RE: Cedar Brook, 66-Lot Subdivision & PUD
Tax Map T2S R1W 30CD, Tax Lot 13400, Sherwood, Oregon
City File #: 4193 Date: March 26, 2014

Design Modification Request for private street, nonstandard bulb out, intersection of SW "A" Street and SW Meinecke Parkway (Layout and Spacing) and curb tight sidewalk on east side of SW "A" Street.

Memorandum

Topic: Design Modification Requests.

STANDARD DRAWING TITLE		DRAWING NUMBER
	STANDARD LOCAL STREET EYEBROW		RD-12
	Any alteration of this drawing may not be associated in any way with the City of Sherwood Standard Drawings.	SCALE	DATE
		N.T.S.	JUN' 13

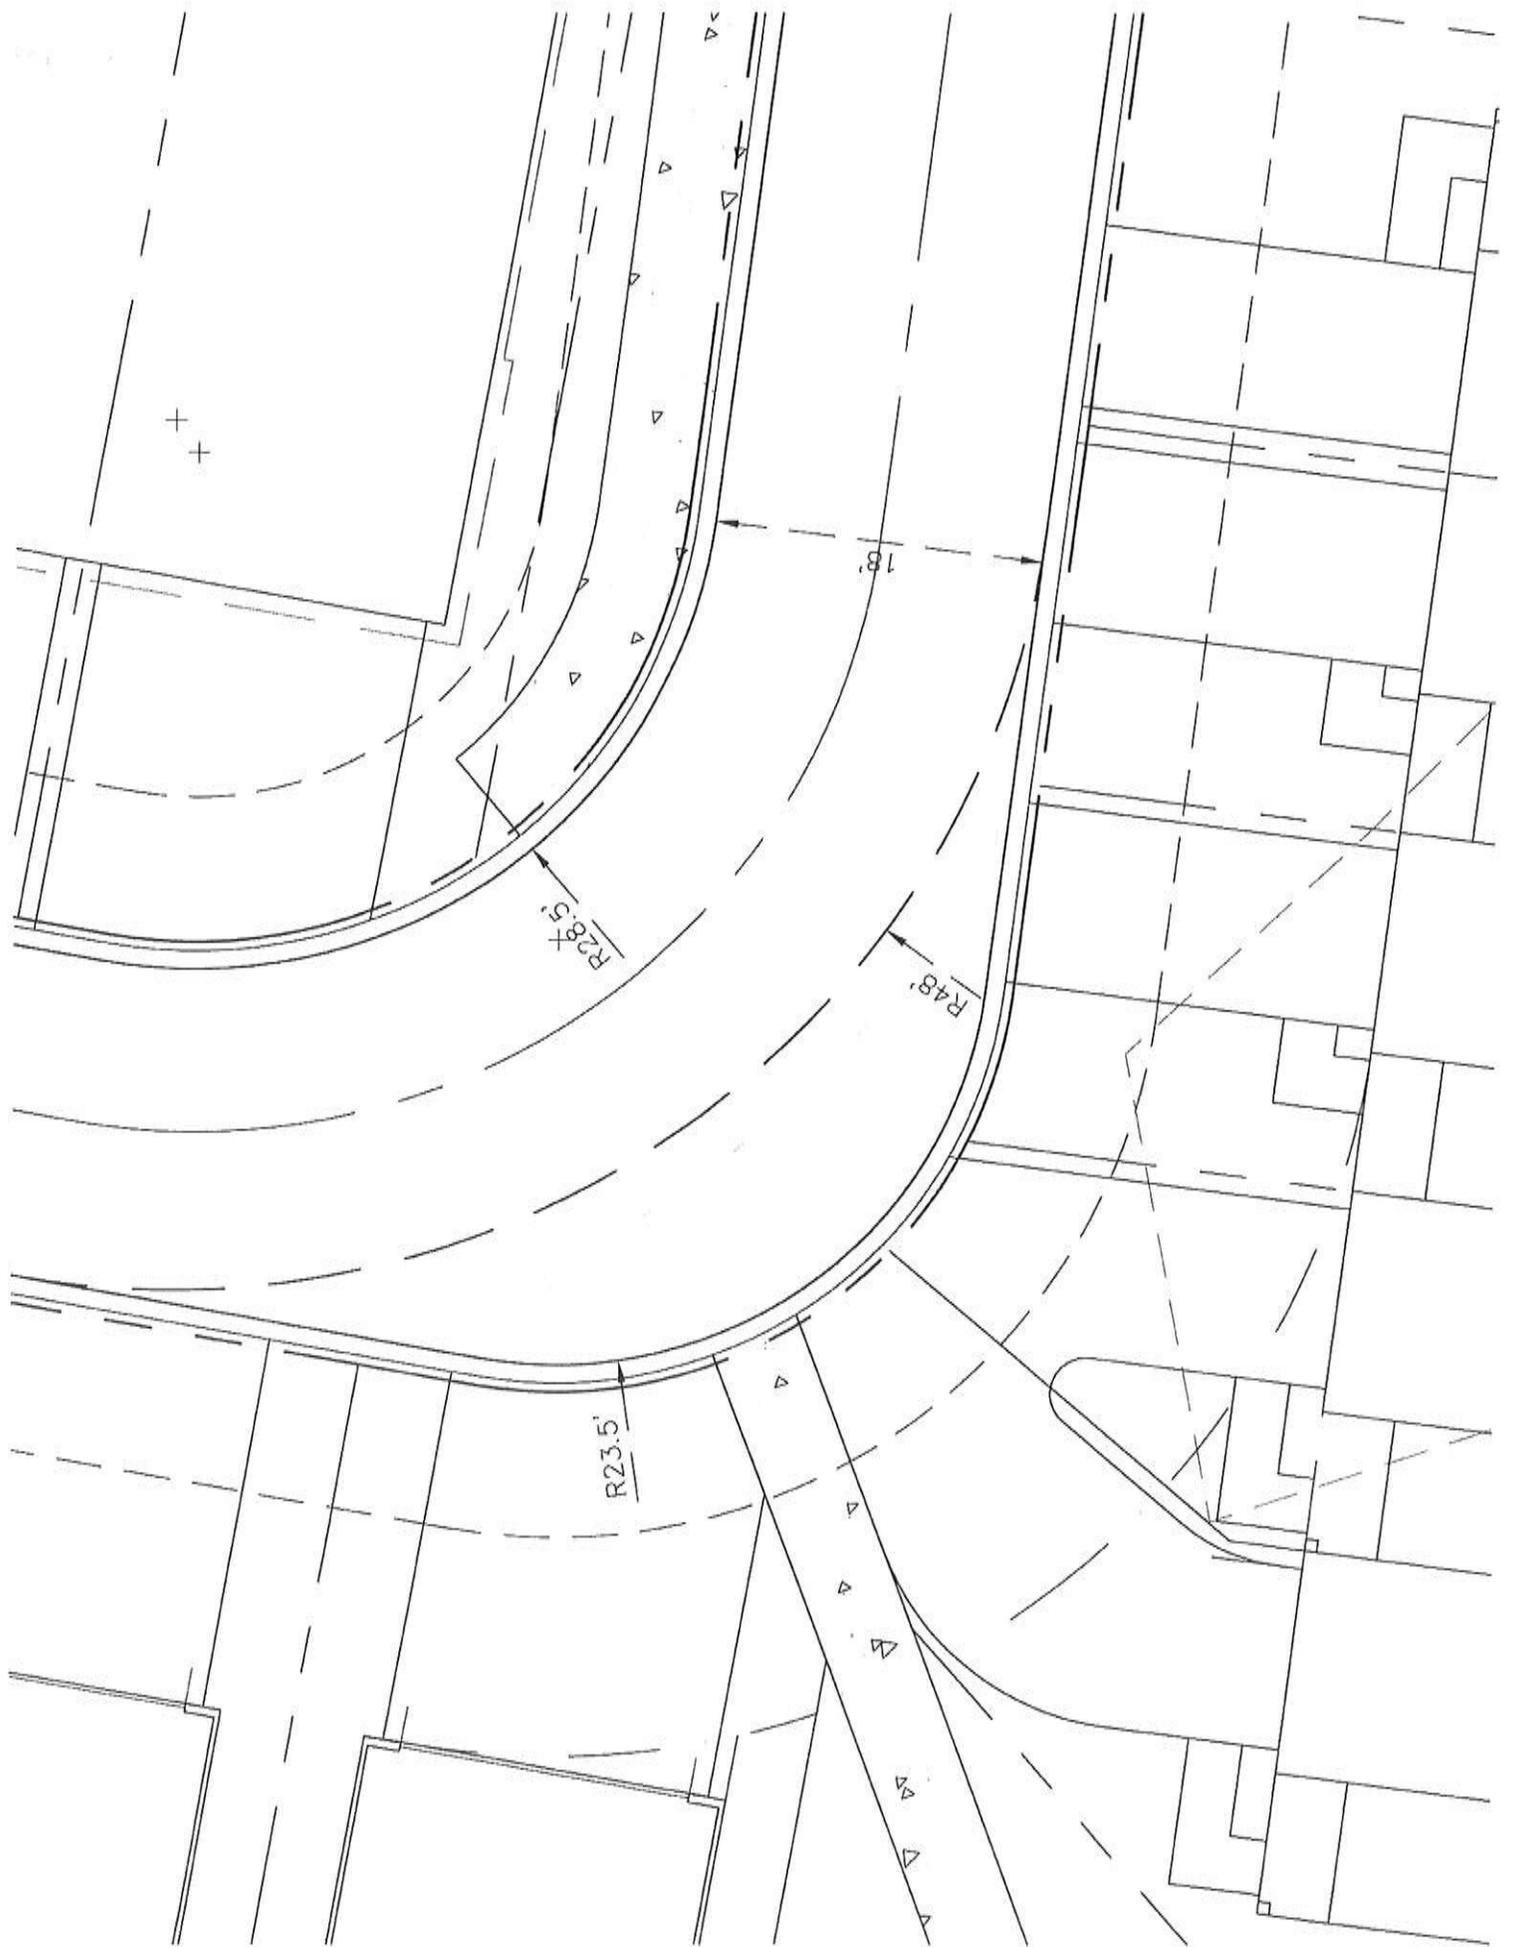
Section 210.7.E states that the outside minimum curb radius of an eyebrow corner is 36 feet; minimum right-of-way radius is 48 feet. According to the attached RD-12 Standard Drawing dated June, 2013, the inside curb radius is also 36 feet.

2. Nonstandard Bulb Out

Because the private street will function as an alley, the bulb out standard for local streets does not apply. The alley inside curb radius at the 90 degree turn is 28 feet and the outside radius is 48 feet in accordance with fire department requirements. The outside curb is widened to allow swing distance for larger vehicles. Additionally, fire hydrants will be provided in accordance with fire department requirements.

Item #2 – Nonstandard Bulb Out

The developer has proposed a bulb out within the private street that will meet emergency access in place of the standard city bulb out (detail RD-12). Since this is a PUD with higher density the standard bulb out would make it considerably difficult to obtain densities since it is beyond the width of the standard right-of-way. The standard bulb out is meant more for standard single family home subdivisions in corner areas of the property to obtain access to the corner. The bulb out proposed appears to give adequate width for a vehicle to pull over for an emergency vehicle. Since the standard bulb out is impractical for use in this situation, I recommend acceptance of the request with the following conditions:

- The inside radius to the back of the rolled curb shall be 28-feet minimum.
- Advanced warning signage be installed due to the sharpness of the curve and potential lack of sight distance due to vehicular parking in the driveway of lot 63.
- The bulb out shall meet the approval of Tualatin Valley Fire and Rescue.
